**Re: Planning Application under Section 16 of Town Planning Ordinance
For Proposed Shui Hau Education Centre on the Approved South Lantau Coast Outline Zoning Plan
No. S/SLC/23 in Shui Hau, Lantau Island, Hong Kong**
- Further Information 01 of S16 Application No. A/SLC/199 -

Proposed Shui Hau Education Centre on the Approved South Lantau Coast Outline Zoning Plan No. S/SLC/23 in Shui Hau, Lantau Island, Hong Kong (Section 16 Application No.: A/SLC/199)

Responses to Comments received from Government Departments via Planning Department on 11.05.2026, 12.05.2026, 18.05.2026 and 19.05.2026 on the Proposed Shui Hau Education Centre – Planning Submission (PS) submitted on 23.04.2026

Drawing Title
EXCAVATION AND FILLING PLAN

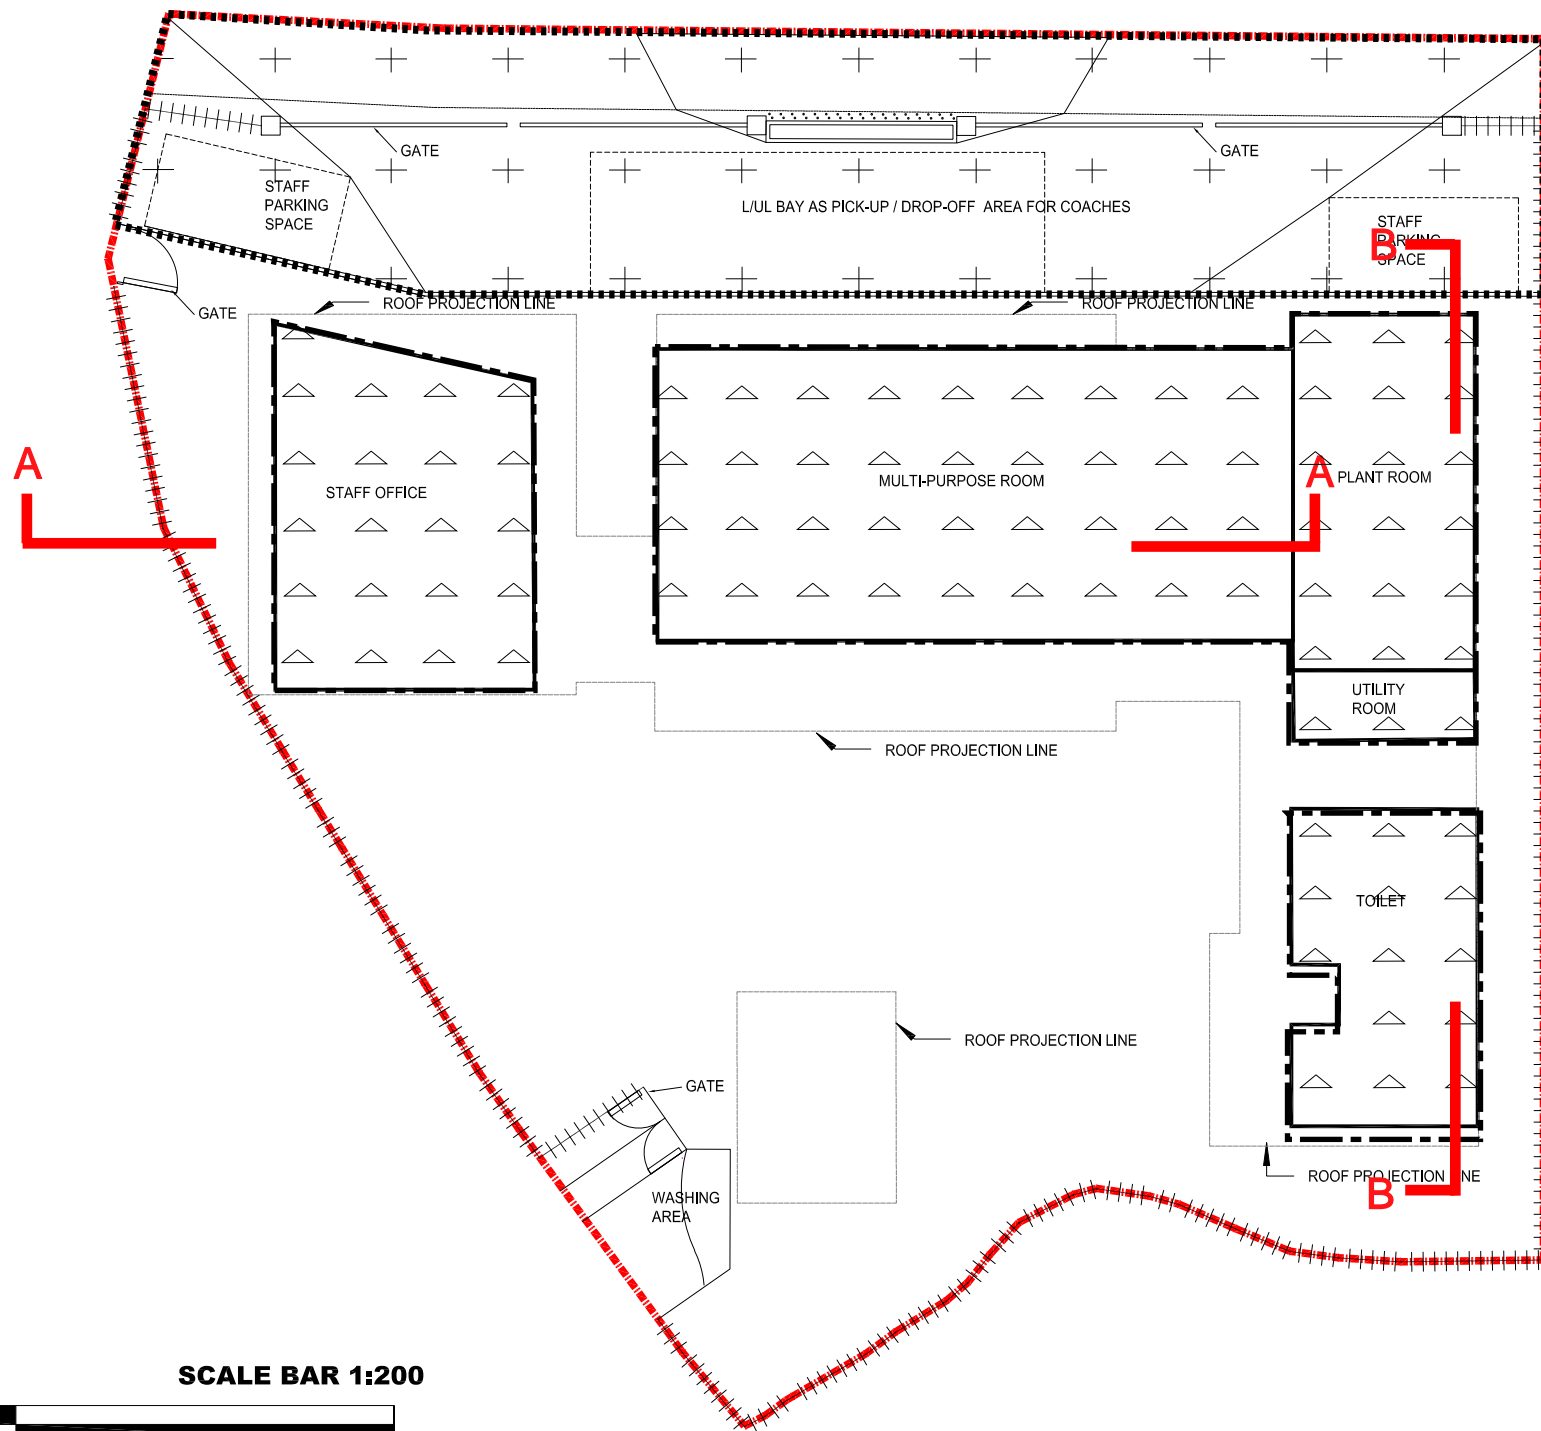
Comments from the District Planning Officer / Sai Kung & Islands, PlanD		
<u>Item</u>	<u>Comments</u>	<u>Responses</u>
5	a. As shown on the Excavation and Filling Plan, please supplement the depth of filling and excavation for foundation works while <u>excluding the height of buildings / structures on ground level after site formation</u> and provide a section plan for better reference. If there is any E&M or ancillary facilities beneath the ground level after site formation, please specify their locations and dimensions.	Supplementary information in response to the comments from the Planning Department is provided in Attachment 3 .
6	b. The subject site falls within an area zoned “Coastal Protection Area” (“CPA) on the approved South Lantau Coast Outline Zoning Plan No. S/SLC/23 (the OZP). While the subject site is also in proximity

Comments from Head of the Geotechnical Engineering Office (GEO), Civil Engineering and Development Department (CEDD)		
<u>Item</u>	<u>Comments</u>	<u>Responses</u>
13	<p>It is noted from the application form and supplementary figure 2 that filling works with height ranging from 2.2m to 5.7m for the foundation works are proposed.</p> <p>The applicant should advise whether the purpose of the proposed filling works is to reinstate the temporary excavation pit back to the existing ground level after construction of the proposed foundation.</p> <p>The application should also advise whether the proposed filling works would result in formation of any temporary or permanent fill slopes.</p>	<p>Excavation works will be required to construct the foundation of the Proposed Centre, with excavation depth ranging from 2.8m to 6.3m. After completion of foundation works, excavated soil will be backfilled to the ground up to site formation level similar to the existing ground level ranging from approx. +2.6mPD to +6.1mPD. The depth of associated filling ranges from 2.2m to 5.7m. As such, the filling works will not result in formation of temporary or permanent fill slopes. The excess excavated soil will be dispatched to public filling reception facilities or other construction sites for reuse. Please refer to the supplementary figures in Attachment 4.</p> <p>Confirmatory ground investigation will be carried out during the construction stage to verify the geological conditions and to optimise the design of foundation works aiming to further minimise the extent of excavation and filling works.</p>

from approximately +2.6mPD to +6.1mPD. The depth of associated filling is expected to range from 2.2m to 5.7m. As such, the filling works will not result in formation of temporary or permanent fill slopes. The excess excavated soil will be dispatched to public filling reception facilities or other construction sites for reuse. Please refer to the supplementary figures in **Attachment 4** of the responses to comments.

21. Confirmatory ground investigation will be carried out during the construction stage to verify the geological conditions and to optimise the design of foundation works aiming to further minimise the extent of excavation and filling works.

Drawing Title
Block Plan (Ground Floor)

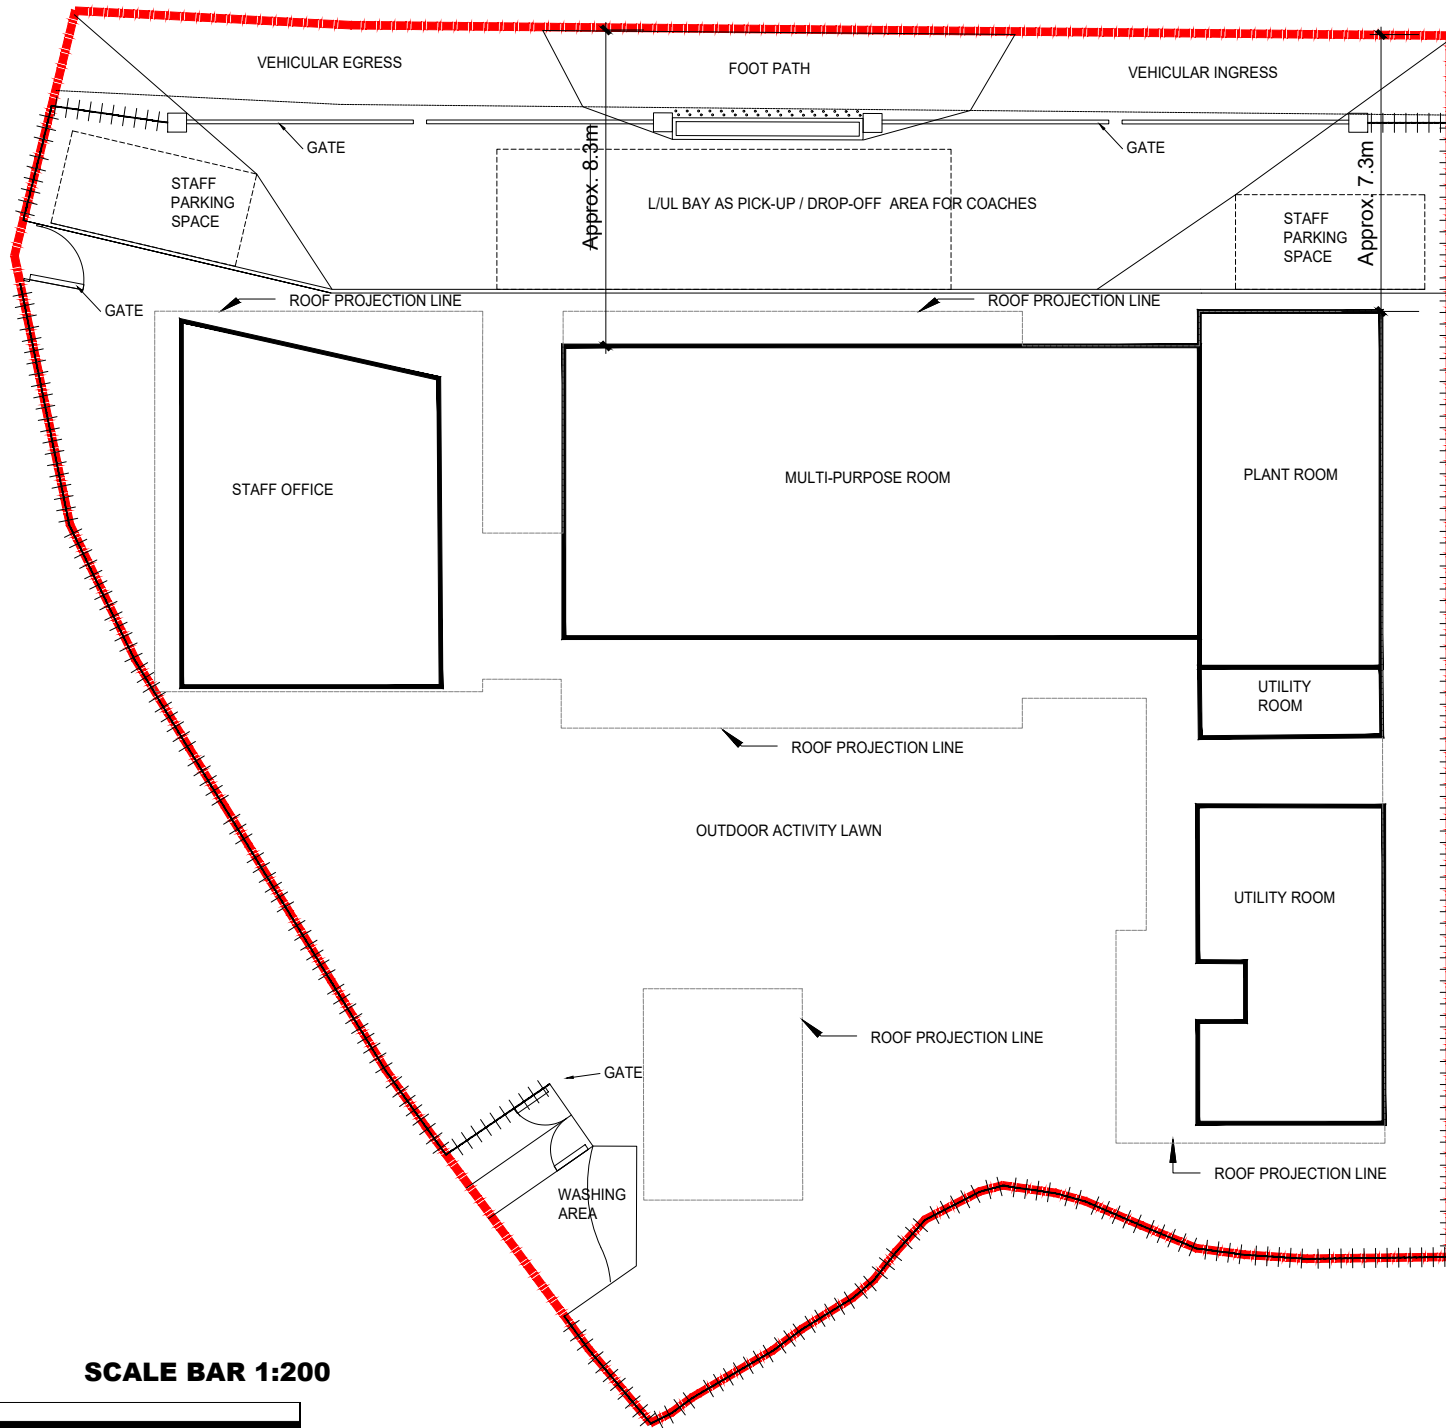
Comments from Chief Town Planner / Urban Design and Landscape, PlanD		
<u>Item</u>	<u>Comments</u>	<u>Responses</u>
14	The applicant may clarify the width of the building setback along South Lantau Road as shown in the Figure 3.1. Please note that the setback should be measured from the plant room rather than the multi-purpose room as the plant room is the structure nearest to South Lantau Road.	Noted. It is confirmed that the setback from the plant room to the South Lantau Road is approx. 7.3m. Appendix B is superseded by the revised version provided in Attachment 5 . Para. 5.6.1, para. 6.3.2, para. 7.4.2, para. 7.5.2, para. 7.6.2, para. 8.1.4 of Appendix K are superseded by the revised version provided in Attachment 6 .
Comments from Director of Environmental Protection, Environmental Protection Department (EPD)		
<u>Item</u>	<u>Comments</u>	<u>Responses</u>
15	<p><u>Noise</u></p> <ul style="list-style-type: none"> • Please clarify whether the office and the multi-purpose room in the Proposed Development are equipped with air conditioning, do not rely on openable windows for ventilation, and are not intended for noise-sensitive use. If affirmative, the quantitative road traffic noise calculation in Section 6.2.15 is not required. • Please provide supporting for the peak traffic flow assumed in the note. • Re. S.6.2.15, it is noted that the staff office will not have openable window facing the roadside, please incorporate such assumption for including “angle of view” in the road traffic noise calculation accordingly. • Re. S.6.2.15, please incorporate nearside façade correction in the road traffic noise calculation accordingly. • 	The office and multi-purpose room will be equipped with air-conditioning and do not rely on opened windows for ventilation. Under this arrangement, the quantitative road traffic noise calculation is considered not relevant. Para. 6.2.15 of Planning Statement is superseded by the revised version provided in Attachment 7 .
